LEXINGTON-FAYETTE URBAN COUNTY GOVERNMENT CONTRACT CHANGE ORDER Page 1 of 11		Date:	October 1, 2025
To (Contractor):		Project:	Clays Mill Road Improvements, Section 1
L-M Asphalt Partners, Ltd.		Location:	CMR - Waco to Harrodsburg
dba ATS Construction		Contract No.	17-2020
3009 Atkinson Ave, Suite 400, Lexington, KY 40509		Original Contract Amt.	\$10,683,653.39
		Cumulative Amount of Previous Change Orders	\$1,373,272.58
		Percent Change - Previous Change Orders	12.85%
		Total Contract Amount Prior to this Change Order	\$12,056,925.97
		Change Order No.	5 - Final
You are hereby requested to comply with the following changes from the contract plans and specification;			
Current Change Order

LEXINGTON-FAYETTE URBAN COUNTY GOVERNMENT CHANGE ORDER				DATE:		October 1, 2025
Change Order #:						5 - Final
CONTRACT #:						17-2020
Project: Clays Mill Road Improvements, Section 1						
You are hereby requested to comply with the following changes from the contract plans and specifications;

Clays Mill Road Improvements, Section 1
Change Order No.5 - Final
Reasons for Porposed Changes

Figure 2

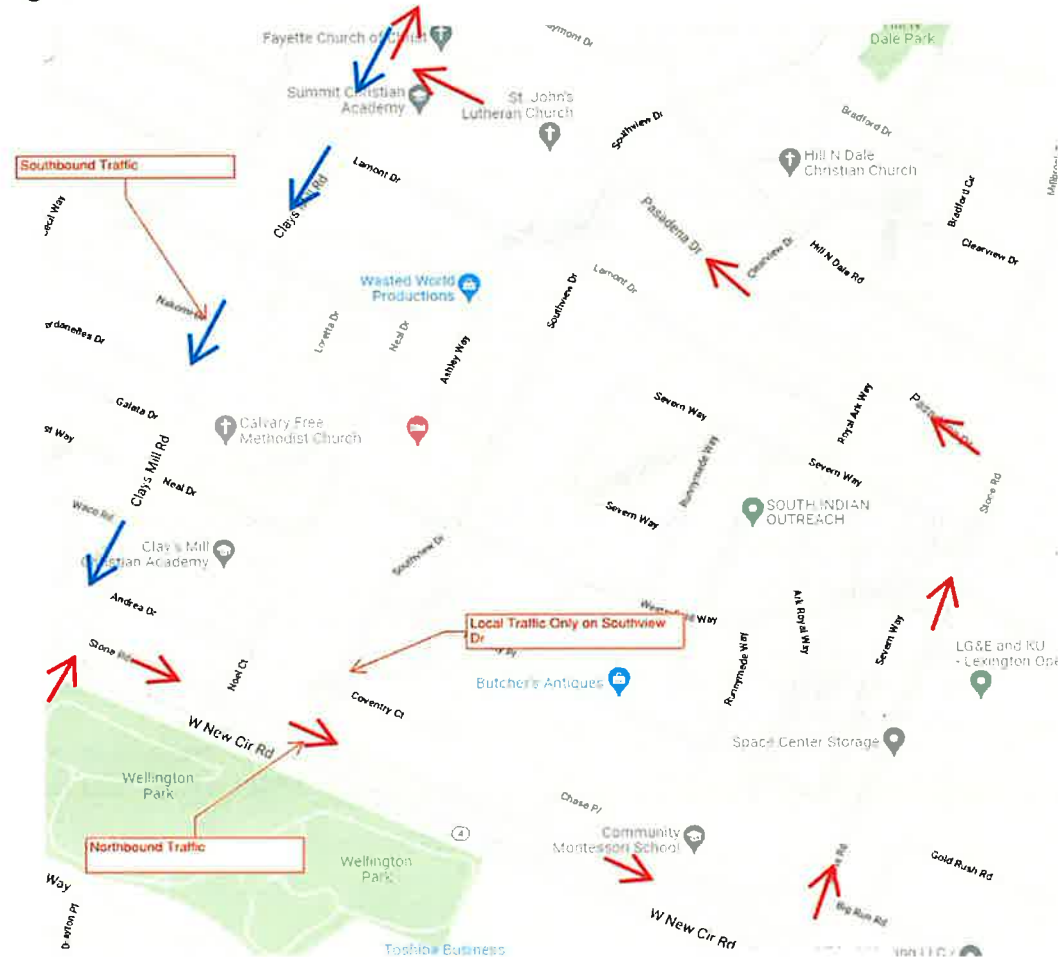
To mitigate this issue, ATS Construction proposes to add an additional phase in which the Northbound Traffic is closed on Clays Mill Road and Detoured around using Stone Road as depicted in Figure 2 below. Construction would be built in such a way that the Northbound lane would only be detoured for approx. 10 business days or less.

1. Keep Traffic as is and Excavate red area (Figure 1).
2. Build Curb, DGA, 2 layers of asphalt base approx. 19' wide and sidewalk
3. Once Sidewalk is completed, close the Northbound lane of Clays Mill Road and put traffic on detour in Figure 2
4. Excavate and construct Blue area (Figure 1) through second asphalt base layer
5. Simultaneously, backfill Curb and Sidewalk and all remaining finish work behind curb.
6. Pave final Asphalt Base Layer, place Temporary Striping, and switch traffic.

RE: Clays Mill Road Widening
BID NO. 17-2020
Entrance Pavement at Retaining Wall Modifications

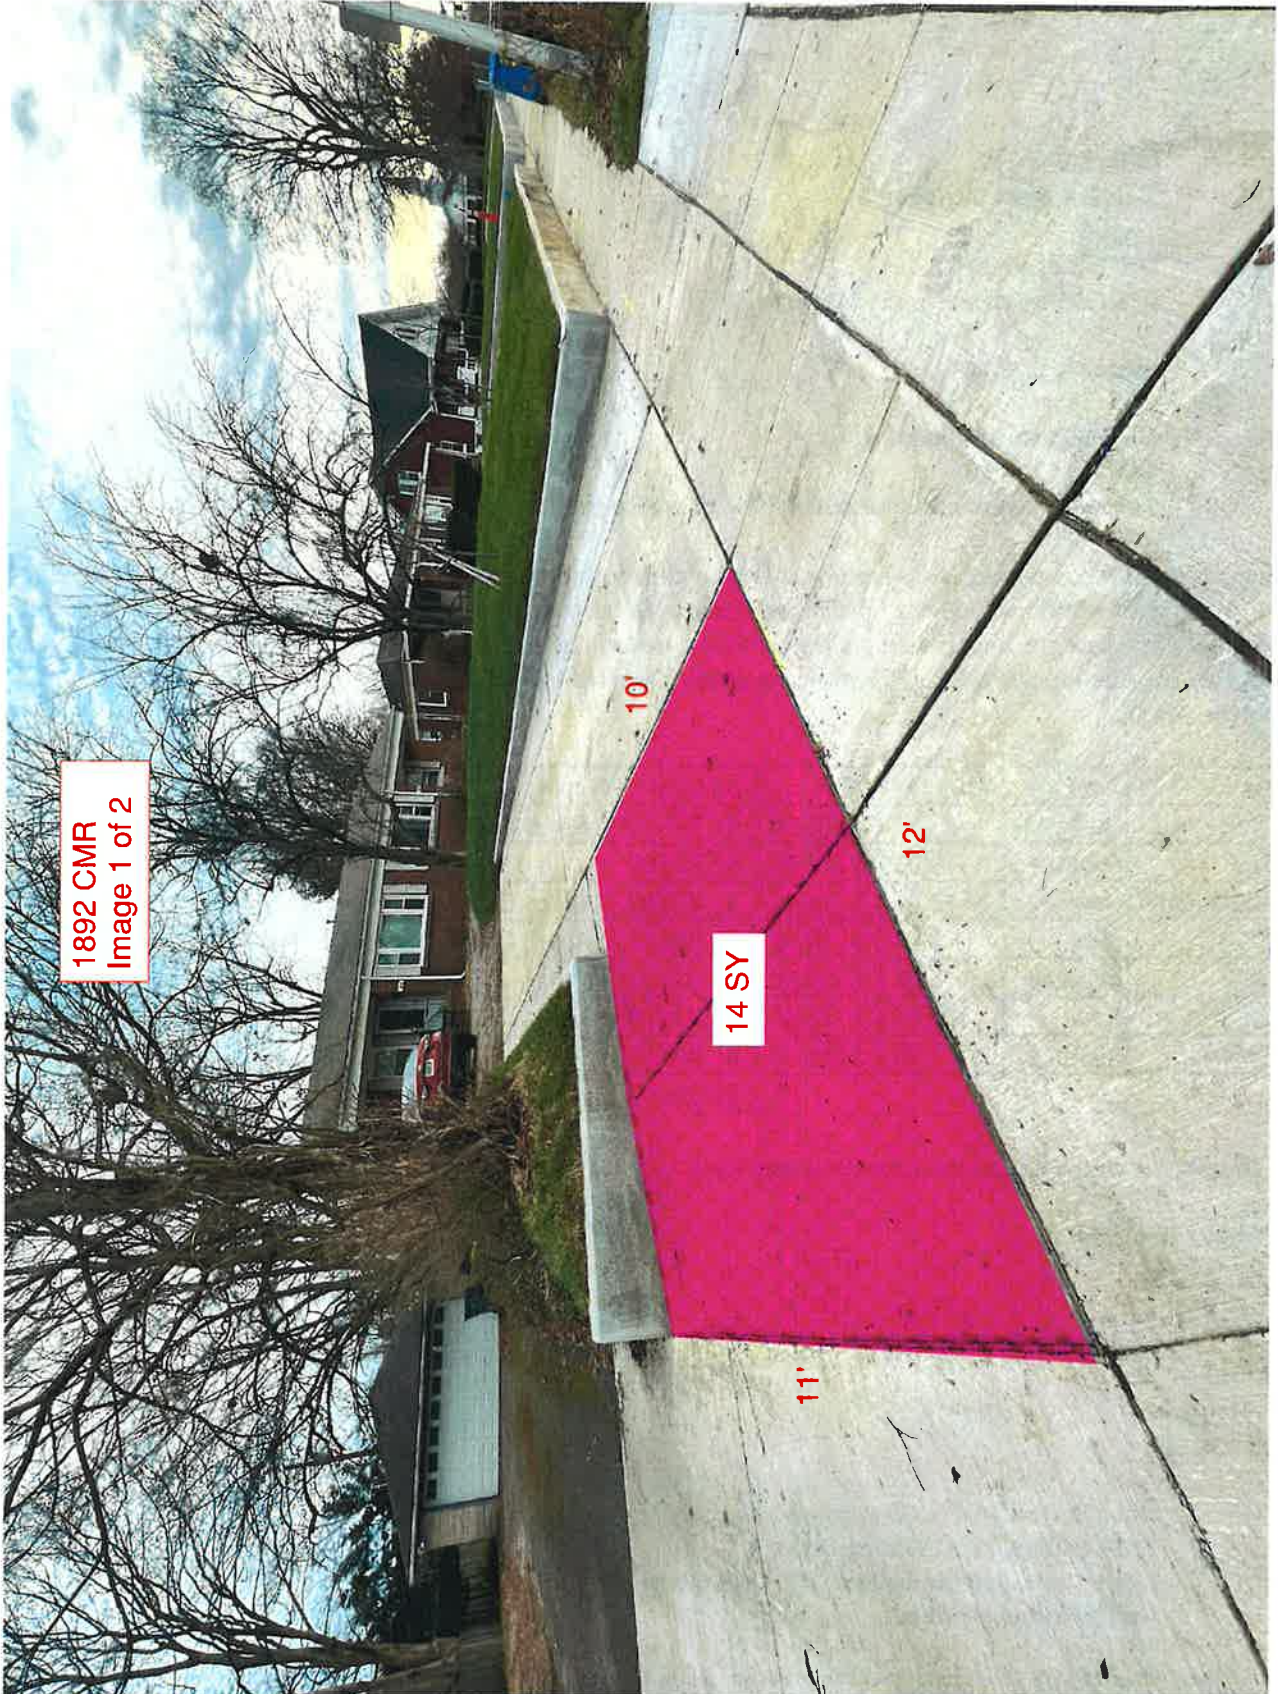
In conjunction with the retaining wall revisions change order proposal (ref # 10099), ATS Construction submits the following pricing for additional driveway pavement completed because of the retaining wall revisions. The pricing is broke out between new entrance pavement and entrance pavement that was removed and replaced. Photos and area breakouts are attached to this letter (Pink=New Pavement, Blue=Remove & Replace). Both options have previously agreed upon pricing.

CLAYS MILL ROAD ENTRANCE PAVEMENT MEASUREMENTS

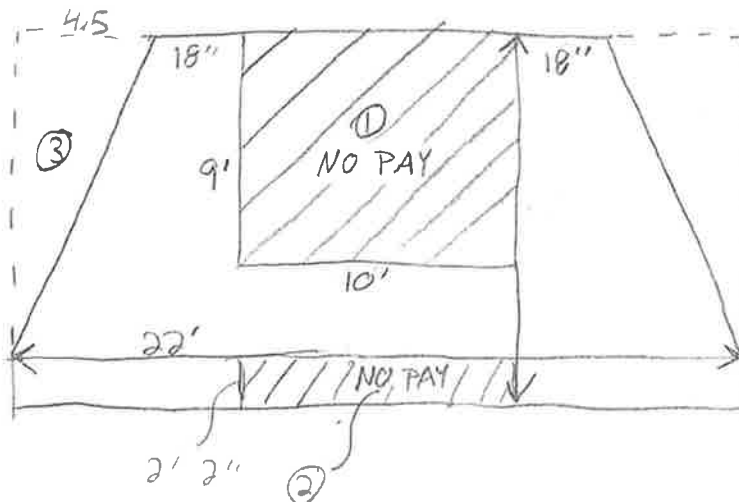
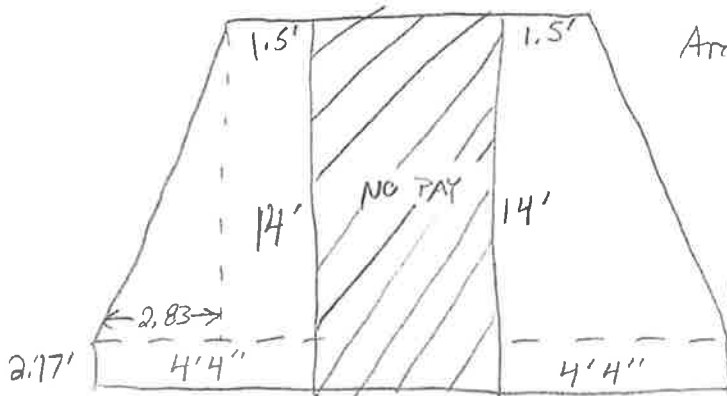
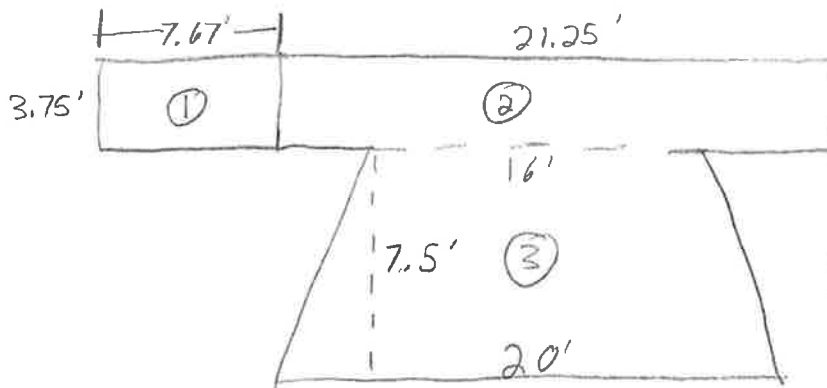
RE: Clays Mill Road Widening
BID NO. 17-2020
Remove and Replace Entrance Pavement

2224 Clays Mill Road
Driveway Reconstruction
1" = 5' on 11 x 17 sheet

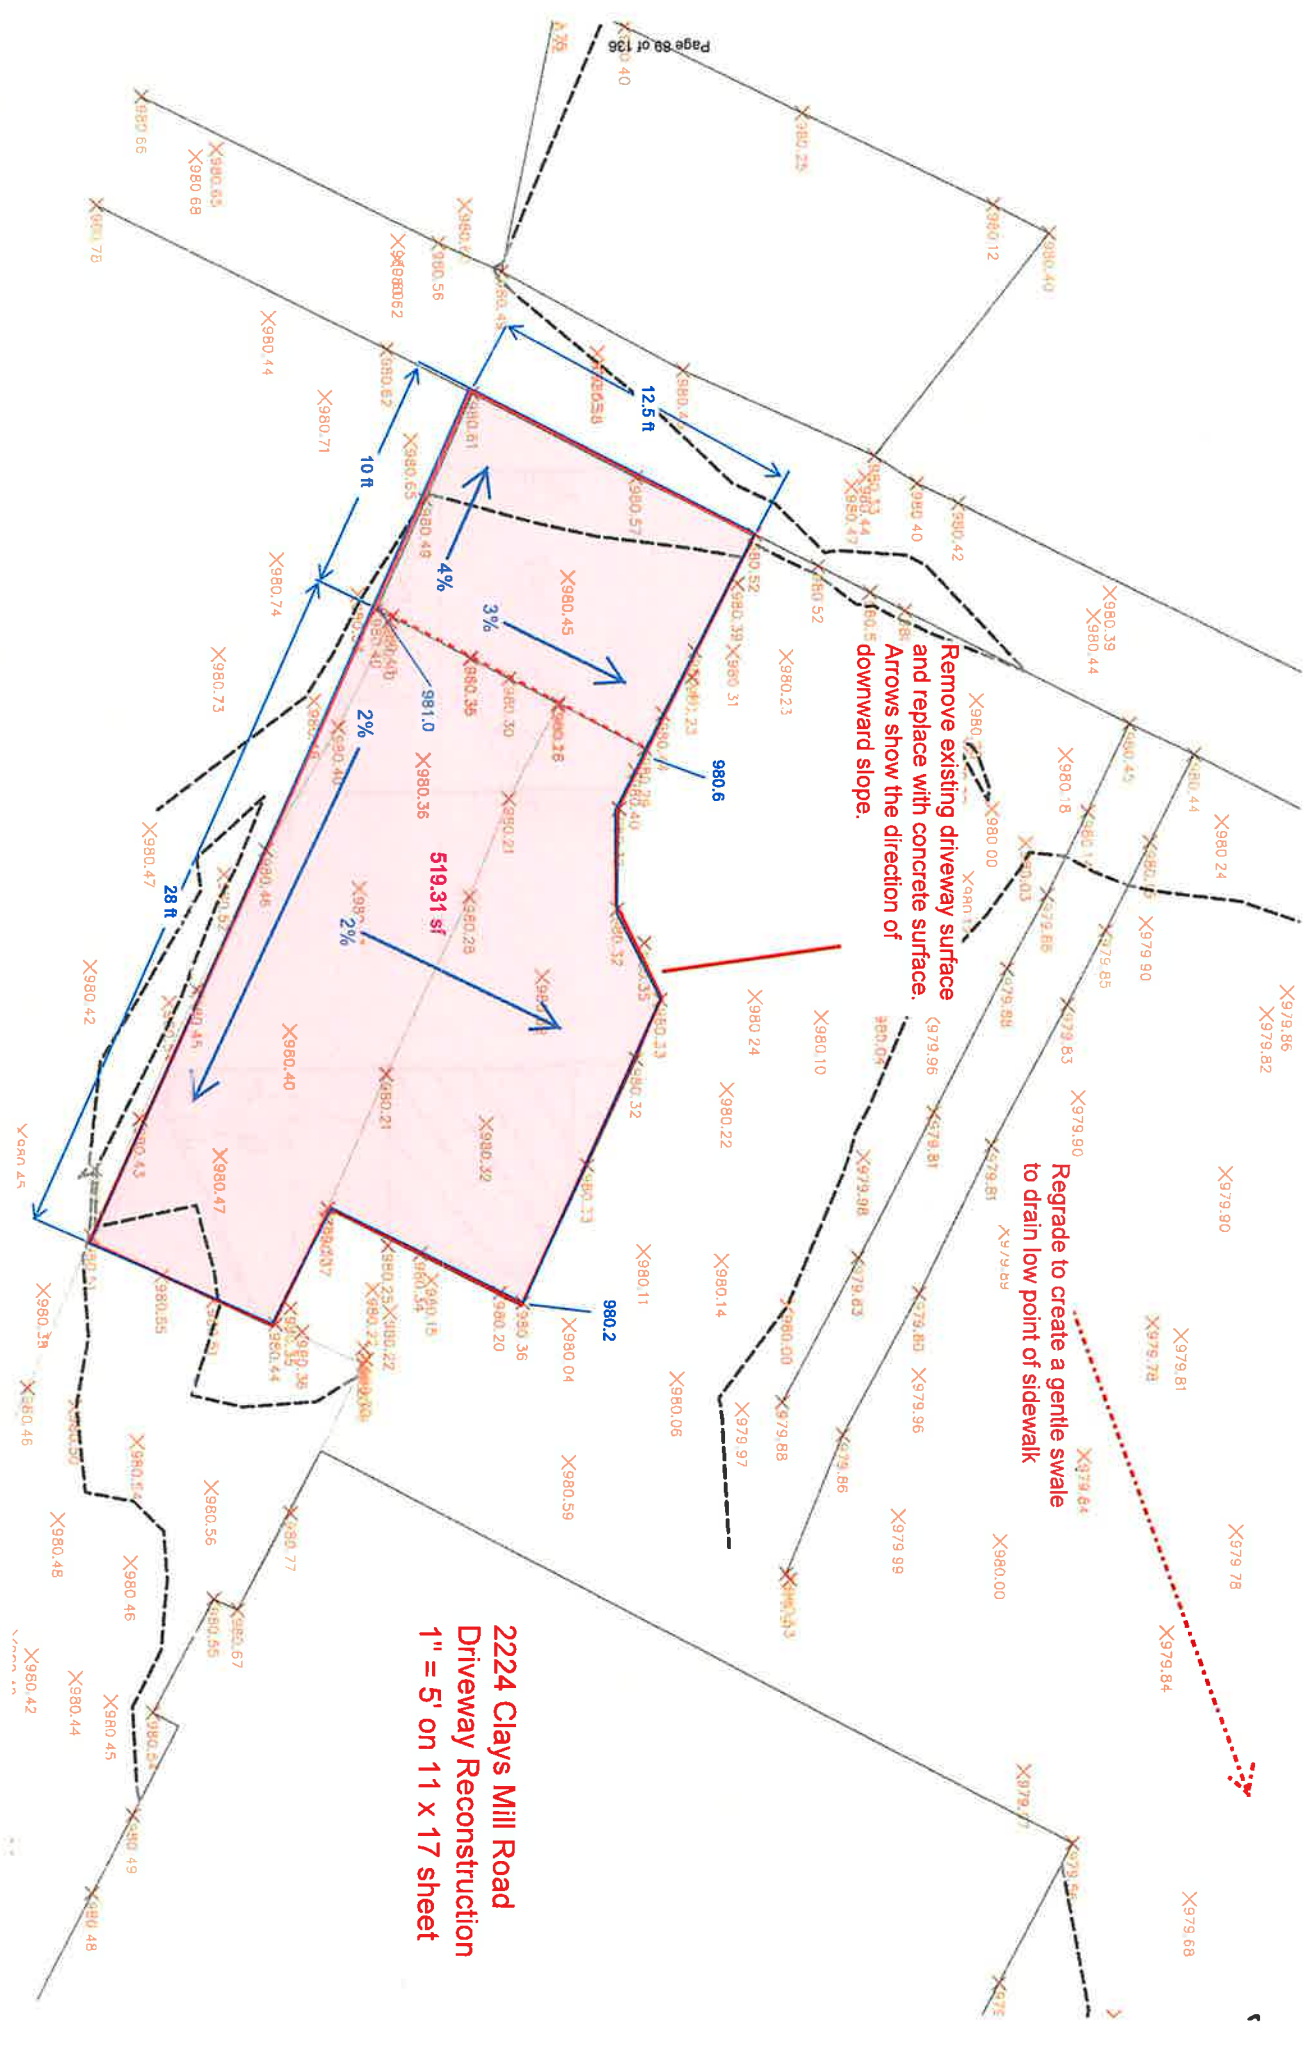
Remove existing driveway surface and replace with concrete surface. Arrows show the direction of downward slope.

PROPOSED TYPICAL DRIVEWAY SECTIONS

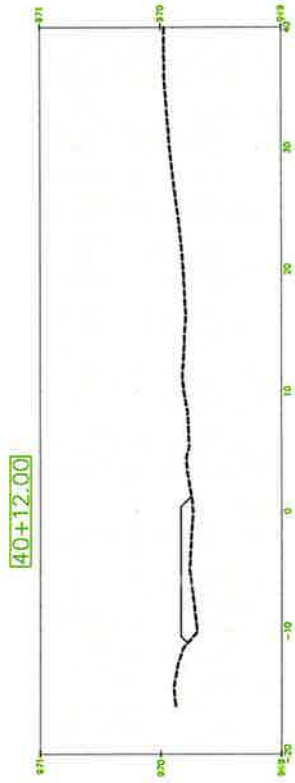
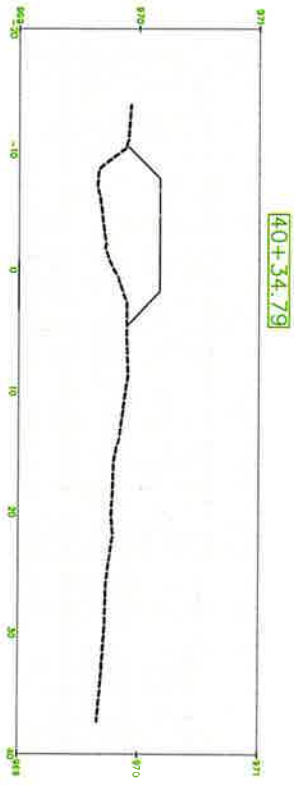
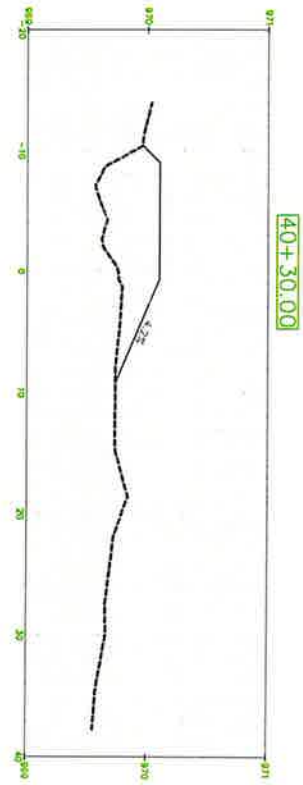
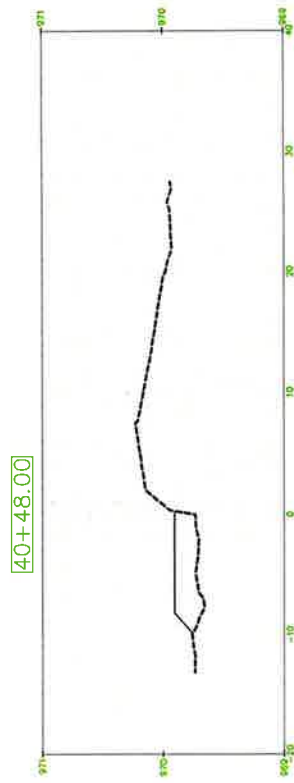
At the request of LFUCG, ATS Construction proposes the following price to remove, regrade, and repave the driveway at 1811 Clays Mill Road per the attached drawing provided by LFUCG.

From: Mark Feibes <mfeibes@lexingtonky.gov>
Sent: Friday, September 20, 2024 10:18 AM
To: Dylan Murphy
Subject: RE: Clays Mill Road - Grass restoration

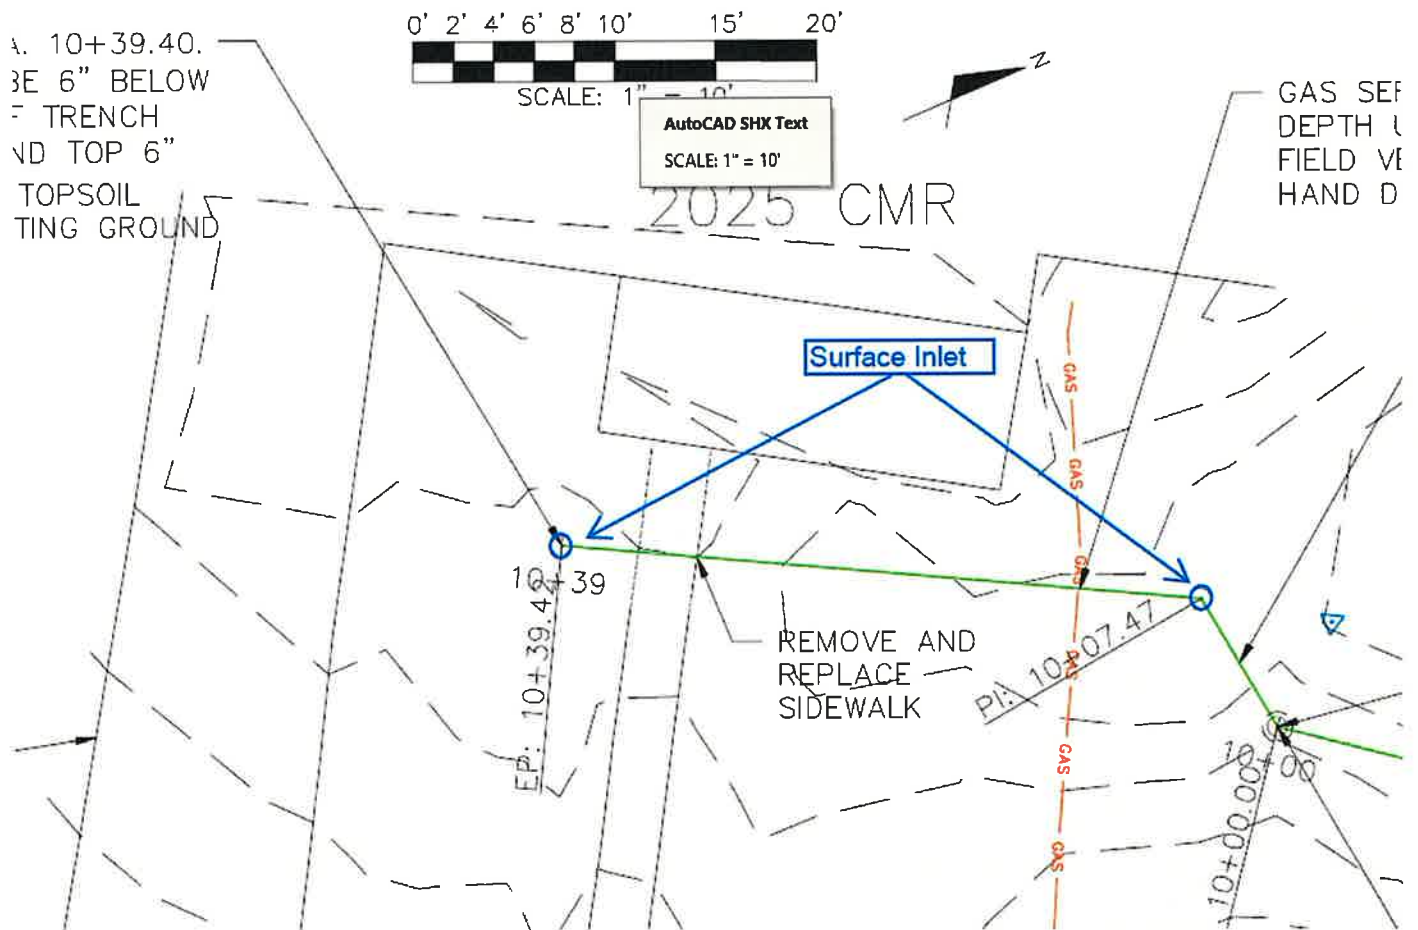
Dylan,
We want to go back to the inlet concept.
